STAFF REPORT
COUNCIL MEETING OF JUNE 8, 2010
BUSINESS ITEM

SUBJECT: DOWNTOWN PARK PARKING FACILITY DESIGN

ALT A1 (2-way)

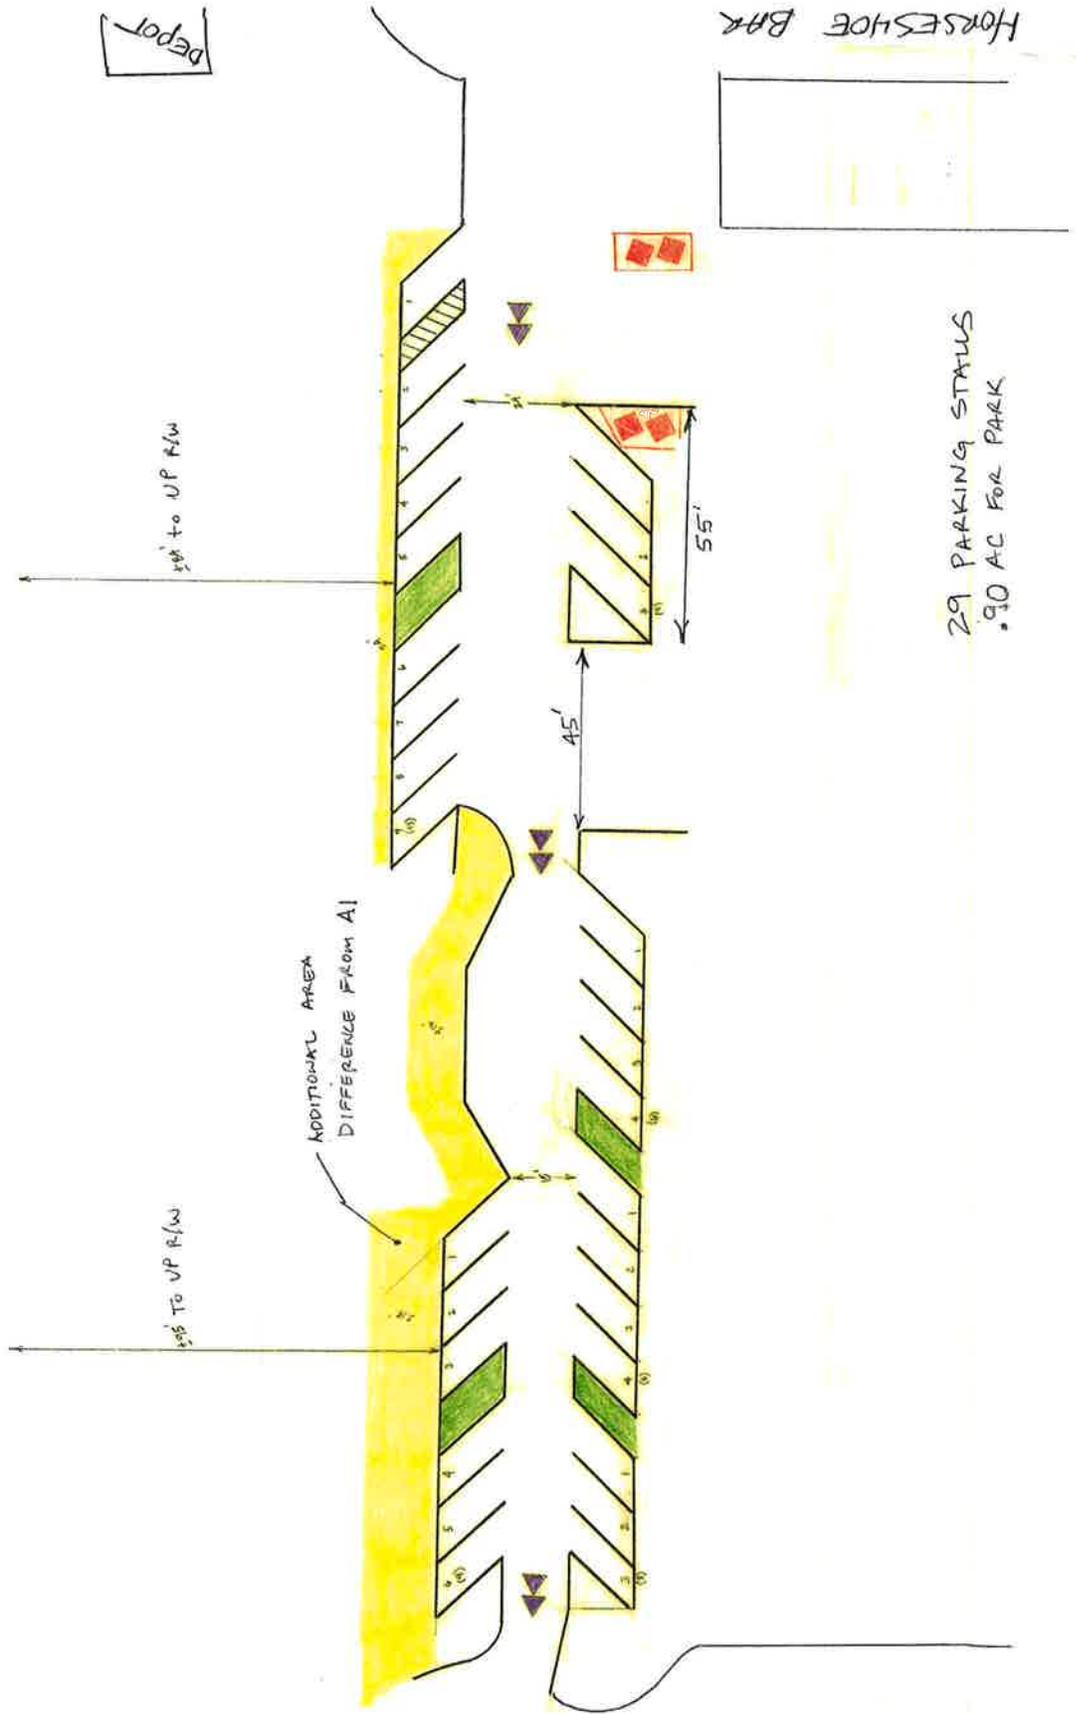
ALTERNATIVE A1

1. Allows roughly 40 parking stalls. Most of any Alternative.
2. Two-way directional traffic allows for better circulation and volume spread in the area. Several different options to enter and exit parking facility should there be traffic back-up in one location.
3. 80 feet of width from UP to parking facility for park improvements. Roughly .77 park acres from Depot to Walnut Street.
4. Accommodating access for larger emergency vehicles.
5. Allows best movement for Nelthorpe trucks and Garbage Trucks.
6. Less traffic conflicts during events and parades.

1. Total width of parking facility is 60 feet.
2. Standard parking lot look.

Greg Obranovich – Selected A1 – No Comments written down.

JC Arisman – Selected Alternative A1 – Change parking lot edge to curve not straight.

Sandra Calvert – Selected Alternative A1 – Would like to see alternative vehicle parking, ie. electric, bicycles, motorcycles, and use drop off as parallel parking or add more stalls. If one way which direction and why?

Jennifer Knisley – Selected Alternative A1 – No drop off parking.

Thomas Seth – Selected Alternative A1 – Eliminate drop off area in middle of parking lot.

ALT A2 (ONEWAY)

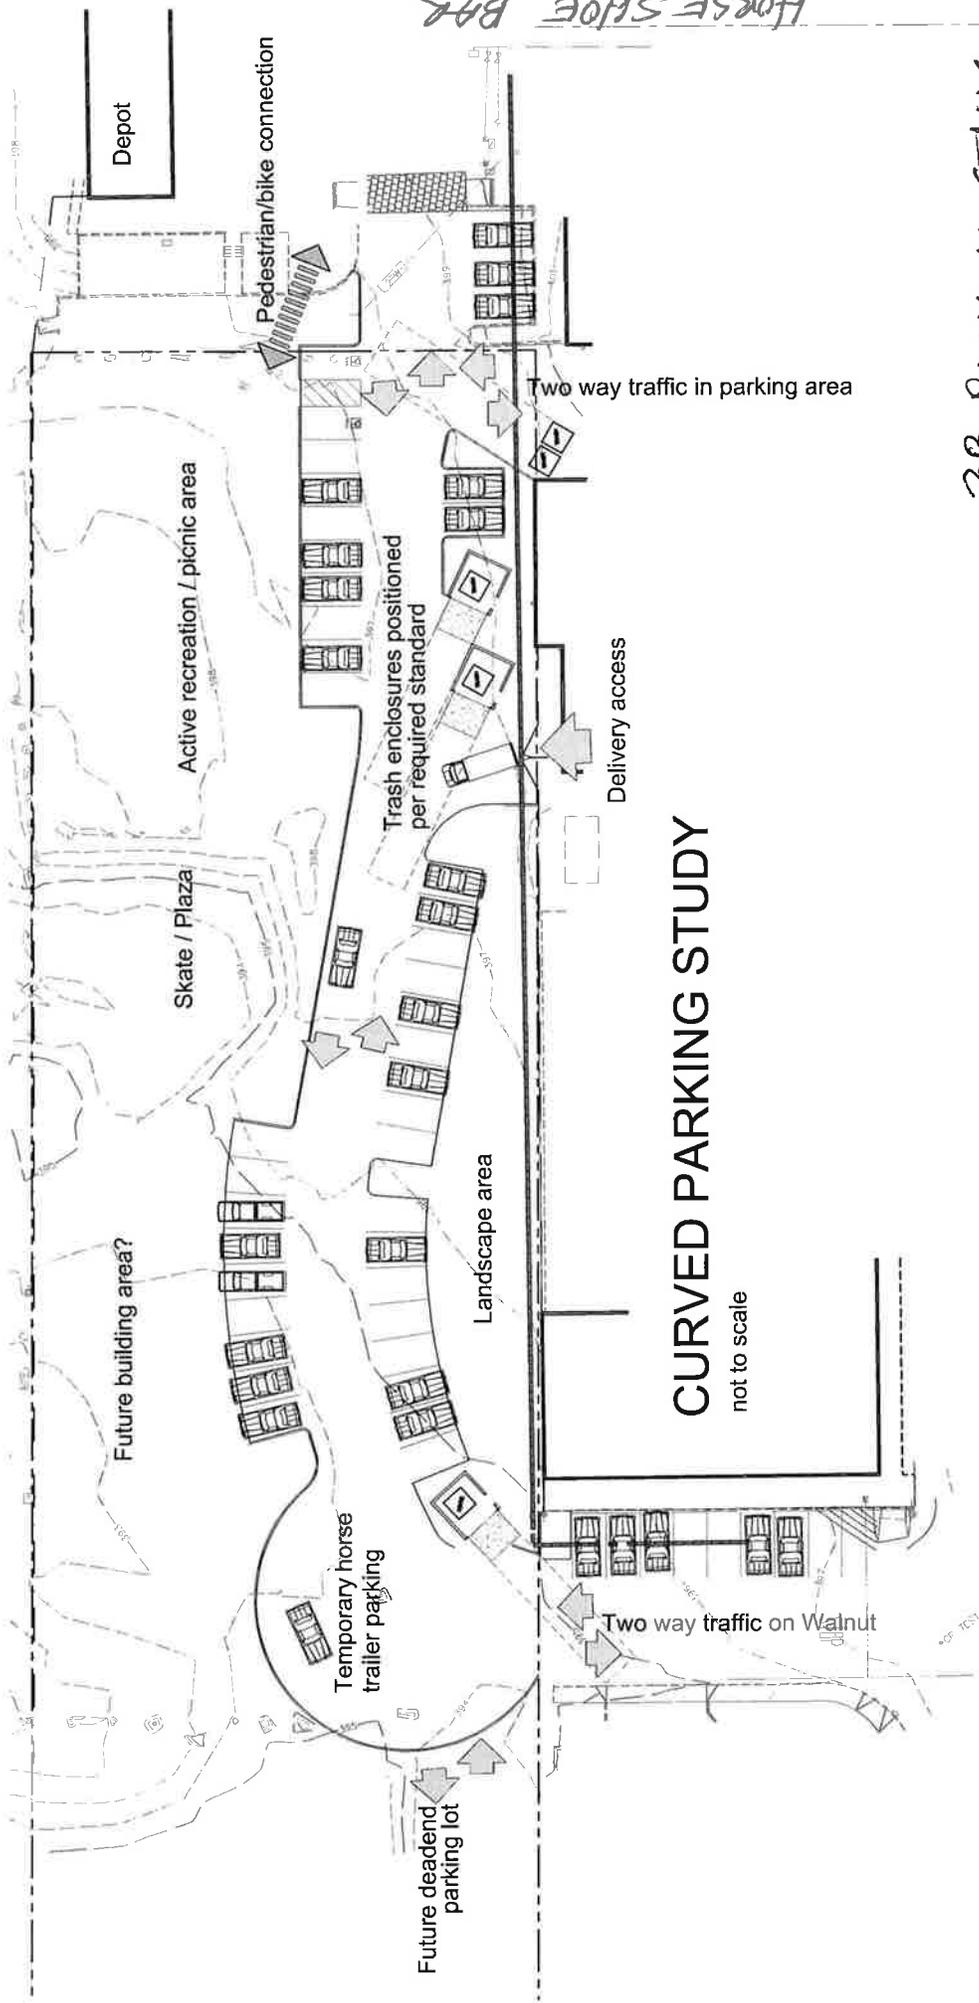
ALTERNATIVE A2

1. 95 feet of width from UP to parking facility for park improvements. Roughly .90 park acres from Depot to Walnut Street. Best of the four alternatives.
2. Could slow down vehicle speeds.
3. Less vehicle conflicts backing-up.

1. Only 29 parking stalls. Lowest of the four alternatives.
2. Restricts circulation and pushes vehicles toward one location. If traffic direction is from the Depot to Walnut, vehicles forced to an un-signalized intersection. Could back up traffic on Walnut preventing Christensen customers from backing out of the parking stall next to the building, horse trailers from maneuvering in the area and stop the circulation of US Bank customers. New signal estimated at \$250k. 18-wheel trucks for Nelthorpe could block the one-way segment of the parking facility during deliveries.

If one-way traffic direction is from Walnut to Depot, vehicle back-up could occur at Horseshoe Bar/Taylor intersection to the Depot. It also funnels traffic in to the Nelthorpe area where there will be

tight quarters during deliveries and normal business operations. Note, allowing two-directional traffic from Depot to Nelthorpes may cause conflict adjacent to Nelthorpes where two-direction traffic transitions into one-directional.

3. During events, one-way directional traffic could cause major back-ups. Example: When the Eggplant Festival closes Horseshoe Bar Road, if one-way traffic is going from the Depot to Walnut, it forces traffic through the private Subway parking lot and restricts vehicles from entering from Walnut. This would cause back-ups on Taylor Road with northbound vehicles wanting to turn left into the Subway parking lot. If one-way traffic is going from Walnut to the Depot, again it forces traffic through the subway parking lot in the other direction causing head on conflict between the Subway parking lot and cars entering from Taylor.

4. Should two-directional be considered in the future, it would be much harder to expand the parking area into the park improvements. Easier to construct landscape strips to narrow two-directional parking area to one-directional configuration.

Janet Thew – Selected Alternative A2 – Decomposed Granite parking lot instead of asphalt. Soft curves along the parking lot wherever possible. Restrict to 2 hour parking. Tell employees of businesses to park elsewhere.

Kim Fettke – Selected Alternative A2 – “Naturalize” the lot by adding curves to curbing rather than a big curve to the roadway. Lose drop off and use cul-de-sacs on each end instead. One Way from Christensens to Depot. Employee parking in Depot lot. Put 2-3 hour parking limit in new parking lot. Combine trash areas.

ALT B2 (one way)

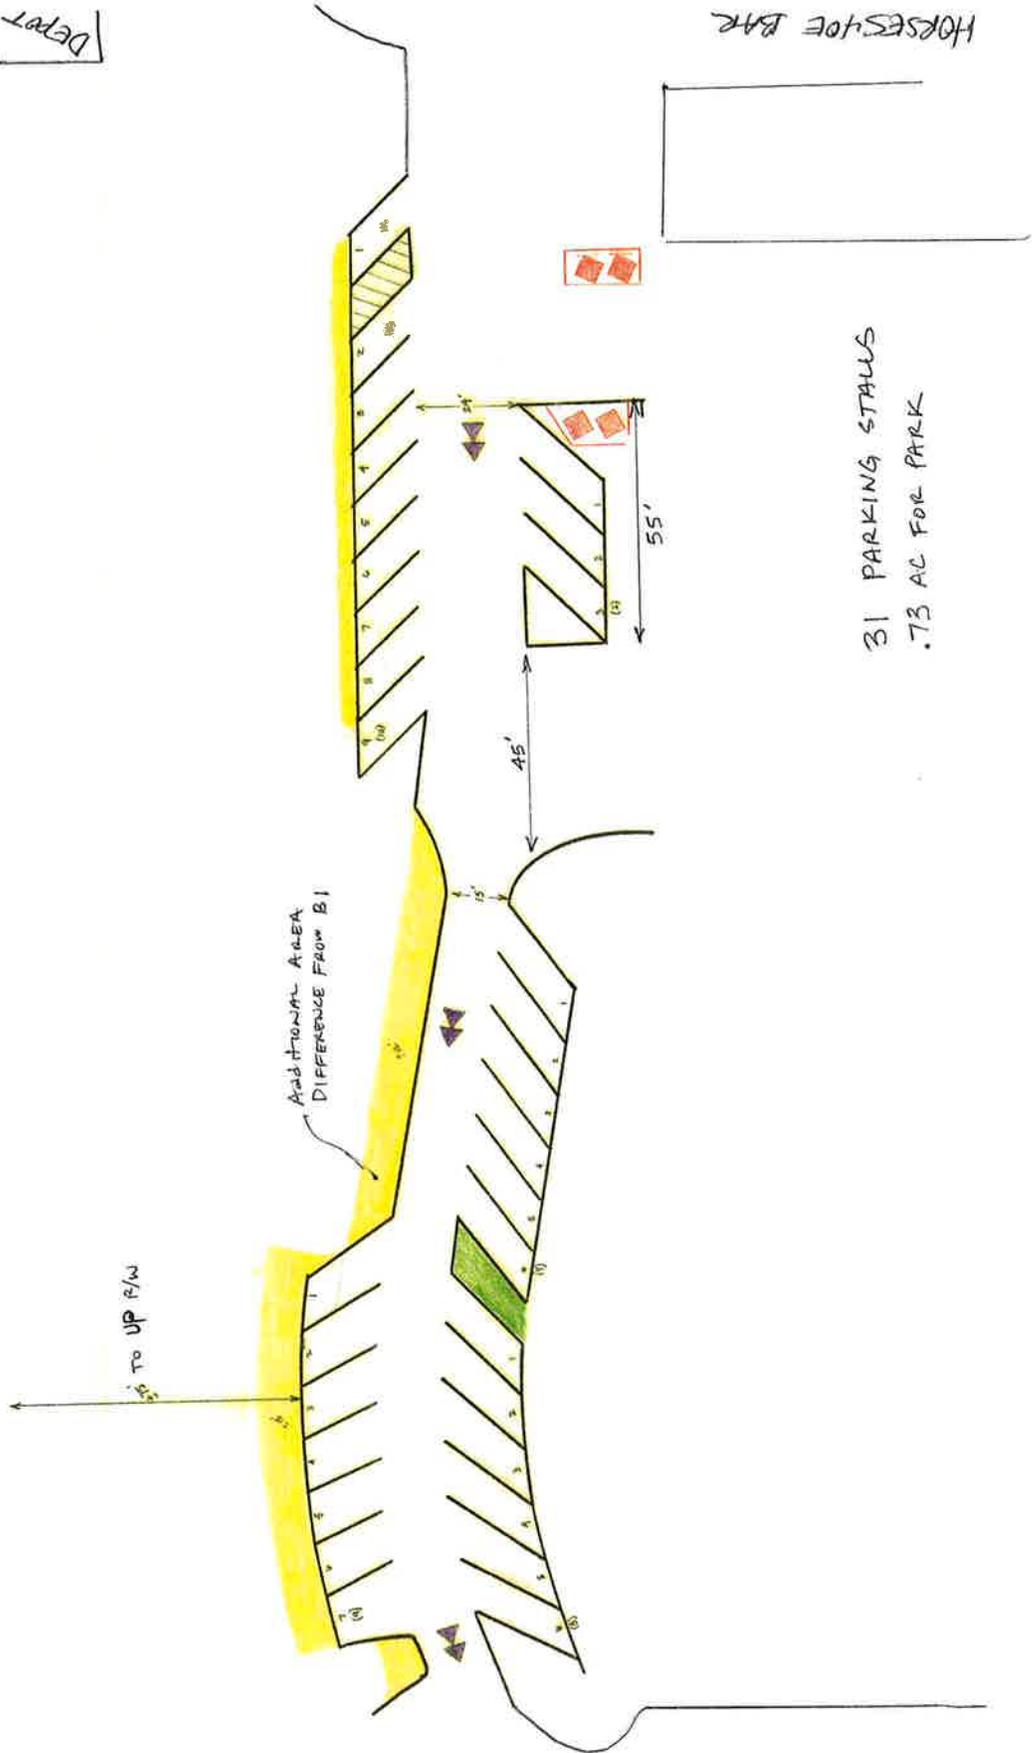
ALTERNATIVE B2

1. Gives a different look than the standard parking facilities,
2. Additional planting area on the Wells Fargo Side of the parking facility.

3. Could slow down vehicle speeds.
4. Less vehicle conflicts backing-up.

1. Only 31 parking stalls.
2. Restricts circulation and pushes vehicles toward one location. If traffic direction is from the Depot to Walnut, vehicles forced to an un-signalized intersection. Could back up traffic on Walnut preventing Christensen customers from backing out of the parking stall next to the building, horse trailers from maneuvering in the area and stop the circulation of US Bank customers. New signal estimated at \$250k. 18-wheel trucks for Nelthorpe could block the one-way segment of the parking facility during deliveries.

If one-way traffic direction is from Walnut to Depot, vehicle back-up could occur at Horseshoe Bar/Taylor intersection to the Depot. It also funnels traffic in to the Nelthorpe area where there will be tight quarters during deliveries and normal business operations. Note, allowing two-directional traffic from Depot to Nelthorpes may cause conflict adjacent to Nelthorpes where two-direction traffic transitions into oncoming one-directional traffic.

3. During events, one-way directional traffic could cause major back-ups. Example: When the Eggplant Festival closes Horseshoe Bar Road, if one-way traffic is going from the Depot to Walnut, it forces traffic through the private Subway parking lot and restricts vehicles from entering from Walnut. This would cause back-ups on Taylor Road with northbound vehicles wanting to turn into the Subway parking lot. If one-way traffic is going from Walnut to the Depot, again it forces traffic through the subway parking lot in the other direction causing head on conflict between the one-way parking lot and cars entering from Taylor.
4. Should two-directional be considered in the future, it would be much harder to expand the parking area into the park improvements. Easier to construct landscape strips to narrow two-directional parking area to one-directional configuration.
